Title - Sujet Palace Grand Theatre Foundation Rep	
Solicitation No. - N° de l'invitation EZ899-152418/A	Amendment No. - N° modif. 008
Client Reference No. - N° de référence du client	Date 2015-07-17
GETS Reference No. - N° de référence de SEAG PW-\$PWY-022-7522	
File No. - N° de dossier PWY-5-38030 (022)	CCC No./N° CCC - FMS No./N° VME
Solicitation Closes - L'invitation prend fin at - à 02:00 PM on - le 2015-07-24	
F.O.B. - F.A.B. Plant-Usine: <input type="checkbox"/> Destination: <input checked="" type="checkbox"/> Other-Autre: <input type="checkbox"/>	
Address Enquiries to: - Adresser toutes questions à: Arthur (PWY), Carolyn	Buyer Id - Id de l'acheteur pwy022
Telephone No. - N° de téléphone (604) 775-6667 ()	FAX No. - N° de FAX (604) 775-6633
Destination - of Goods, Services, and Construction: Destination - des biens, services et construction: Parks Canada - Palace Grand Theatre - Dawson City, YT

Amendment 008

Amendment 008 has been raised to incorporate Addendum No. 4.

ADDENDUM No. 4
July 17, 2015

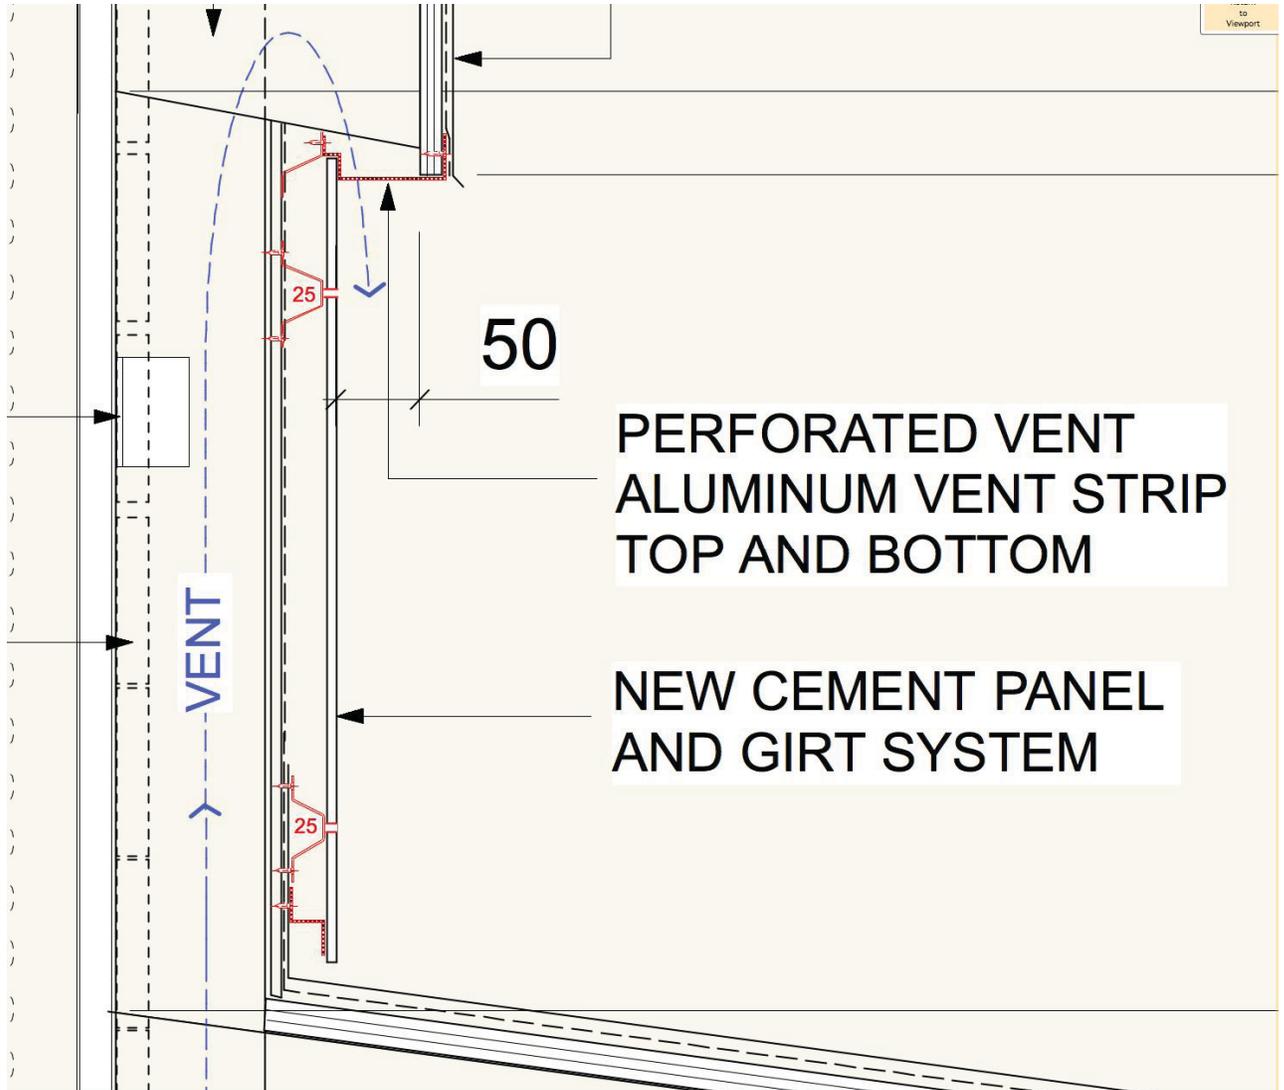
Please provide a specification for the perforated aluminum vent strip as well as a connection detail for the vent strip including connection detail to the new cement panel wall.

Ventilation screens to match material used with proprietary cement panel cladding system, screen should be 0.7mm thick aluminum, 30% open area, no margins, a perforated pattern with minimum hole dia 2mm, @ 5.5mm staggered centres.
Refer to detail below depicting Top and Bottom locations of vent screens attachments and clarification of sub girt depth as 25mm.

1) Drawing A4, 2/A1 NORTH ELEVATION

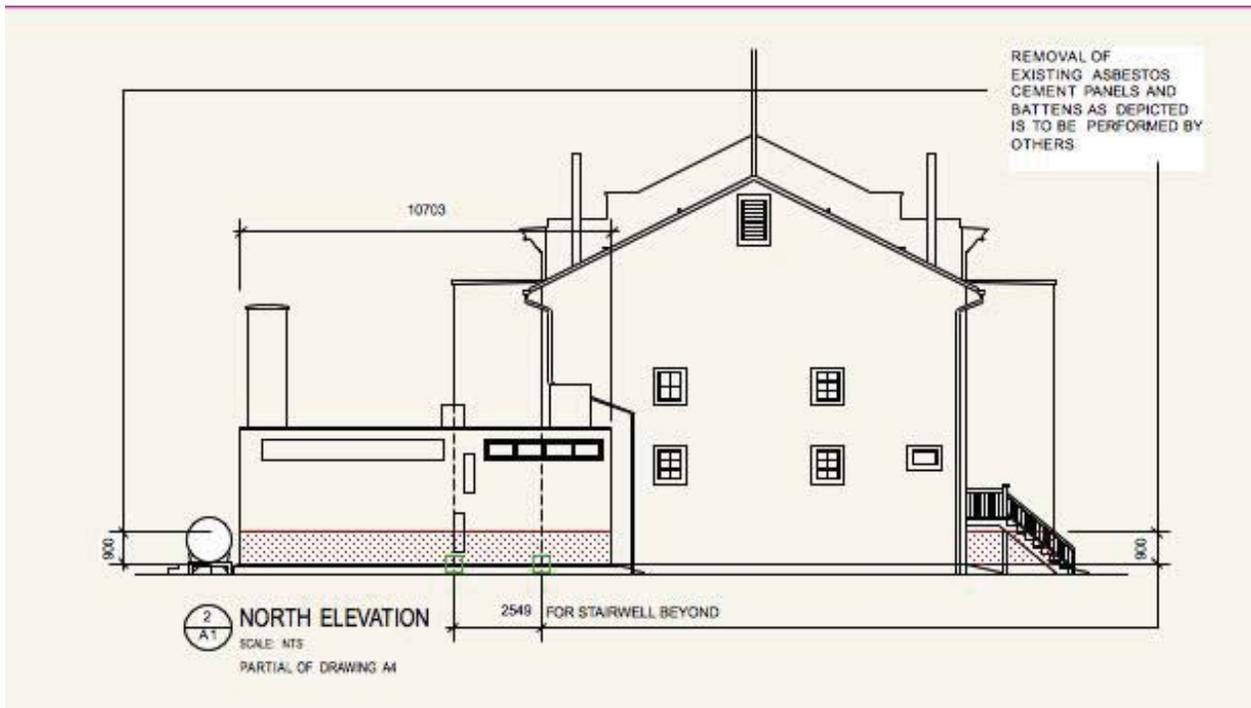
- .1 Delete the removal of asbestos cement panel for extent shown on attached partial sketch.
This work is to be performed by others

2) Drawing A4, 1/A1 EAST ELEVATION

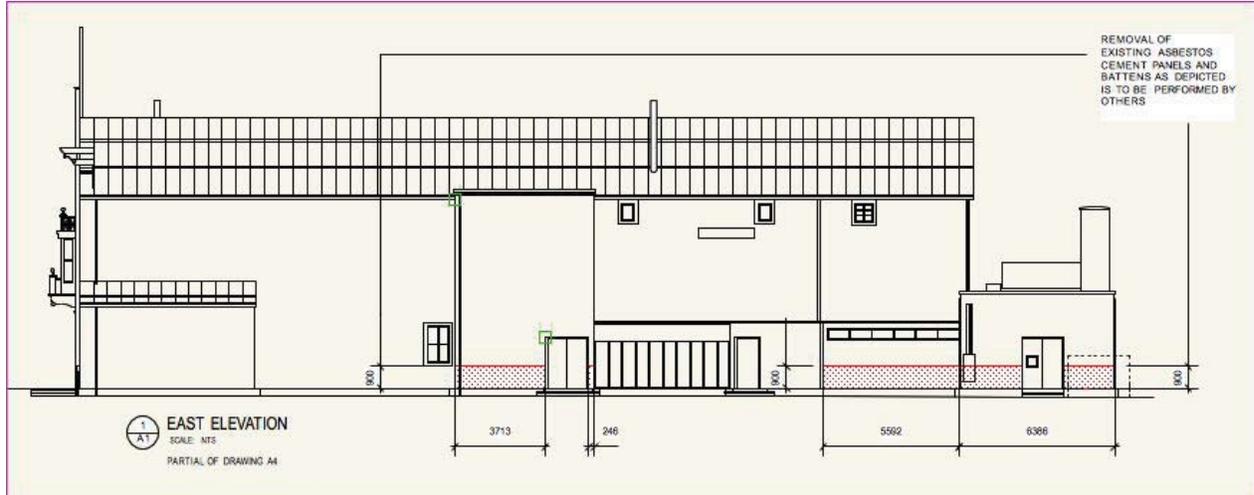
- .1 Delete the removal of asbestos cement panel for extent shown on attached partial sketch. This work is to be performed by others

3) Drawing A5, 1/A1 WEST ELEVATION

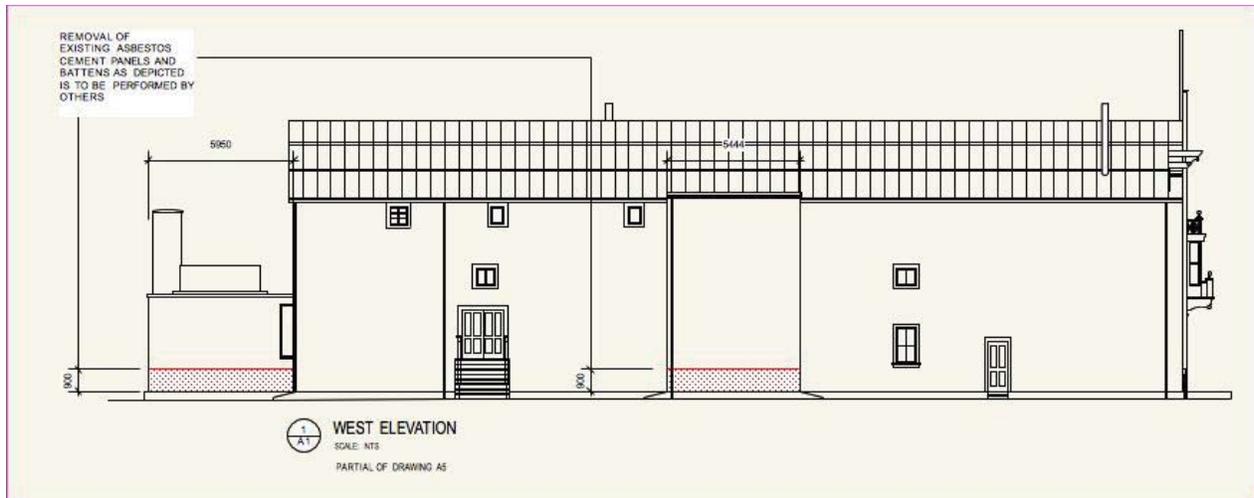
- .1 Delete the removal of asbestos cement panel for extent shown on attached partial sketch. This work is to be performed by others

4) Refer to New sketch SOUTH ELEVATION

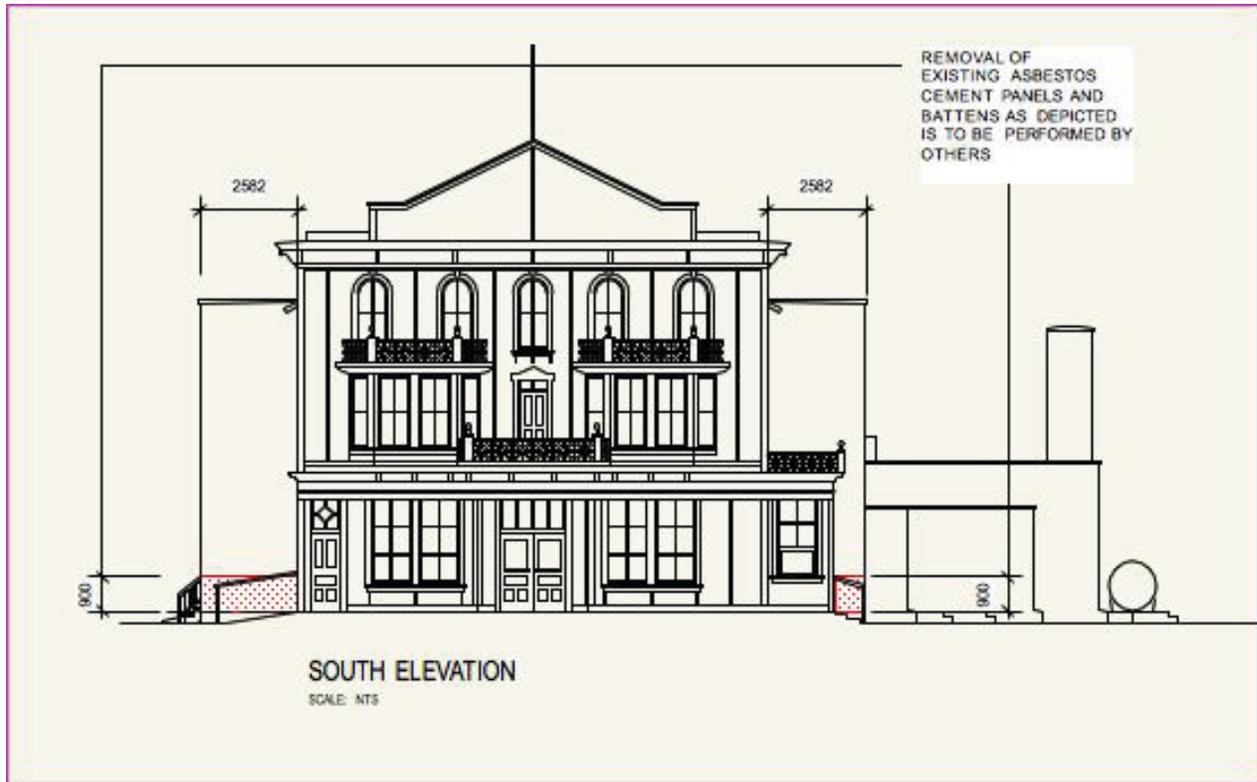
- .1 Delete the removal of asbestos cement panel for extent shown on attached sketch.
This work is to be performed by others
